Unbalance

Rev. 3

MICHAEL PAUL

Figure 145-22—PSE PI unbalance specification and system resistance unbalance

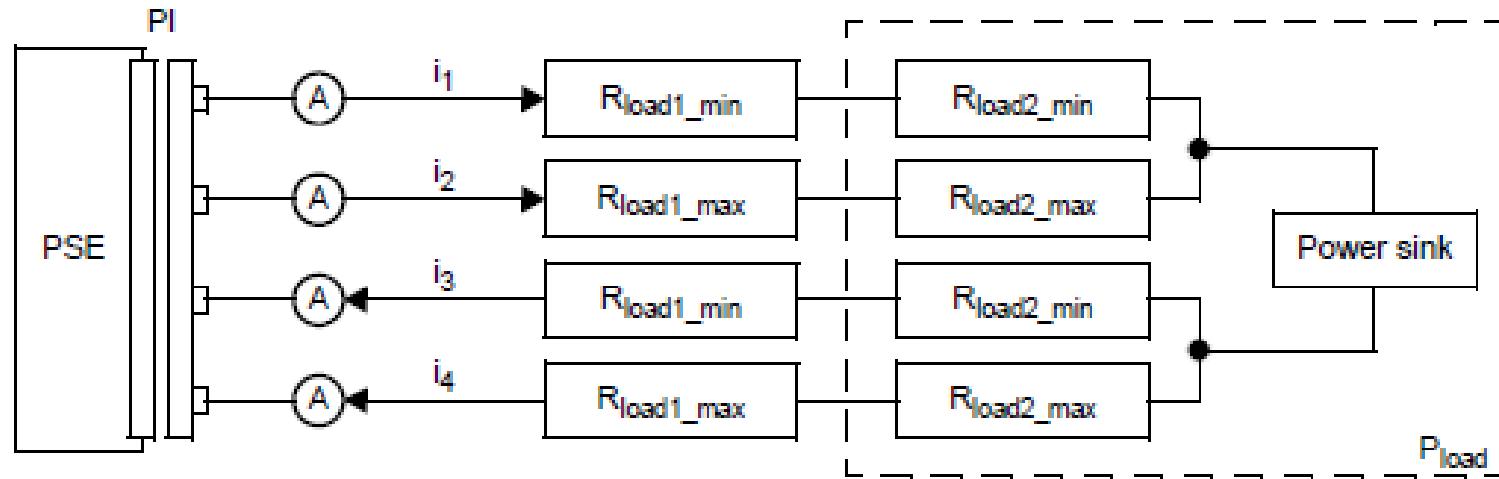
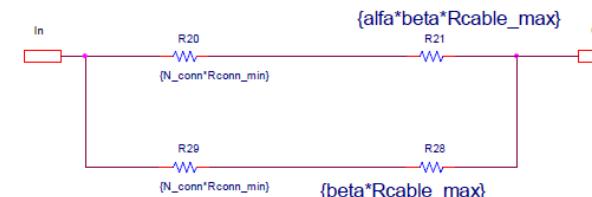
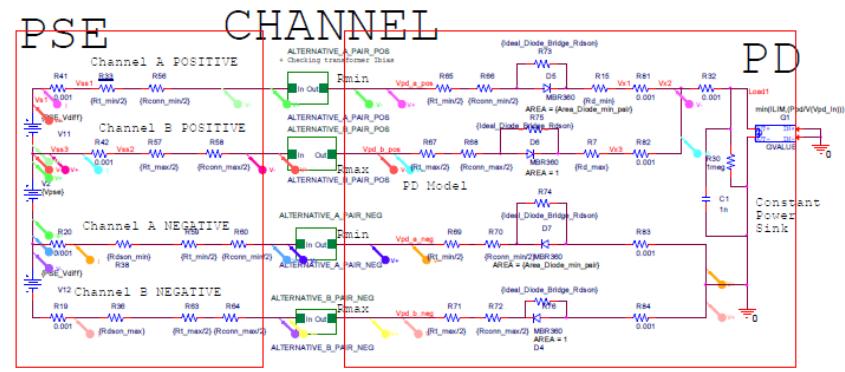
- ▶ Draft 3.1 $I_{\text{Unbalance-2p}}$ was changed to 560mA to provide margin.
 - Now, using the PSE test from table 145-18, $R_{\text{PSE_alpha}}$ can be changed to 2.67 and pass the compliance test
 - That is the PSE can be more unbalanced and pass the hardware compliance test

- ▶ Plugging $R_{PSE_alpha} = 2.67$ back into the System Unbalance model gives $I_{Unbalance-2p,max} = 571mA$
- ▶ This PSE passes the compliance test but may fail to interoperate

► We need two unbalance numbers

- $I_{\text{Unbalance-2p}}$ for the hardware unbalance test (component unbalance contribution)
- $I_{\text{Con-2p-unb}}$ for the system at runtime (software-controlled current threshold)
- The hardware test limit must be less than the runtime unbalance limit to ensure margin

- PSEs and PDs should not exceed $I_{\text{Unbalance-2p}}$ when connected to the test load/source
- $I_{\text{Unbalance-2p}}$ should use the $I_{\text{Con-2p-unb}}$ numbers from Draft 3.0
- Draft 3.0 $I_{\text{Con-2p-unb}}$ numbers define system performance given PSE, cable and PD unbalance allocations

- A PSE should not remove power from a PD until at least $I_{\text{Con-2p-unb}}$ is drawn from a pairset
- $I_{\text{Con-2p-unb}}$ should maintain the numbers specified in Draft 3.1
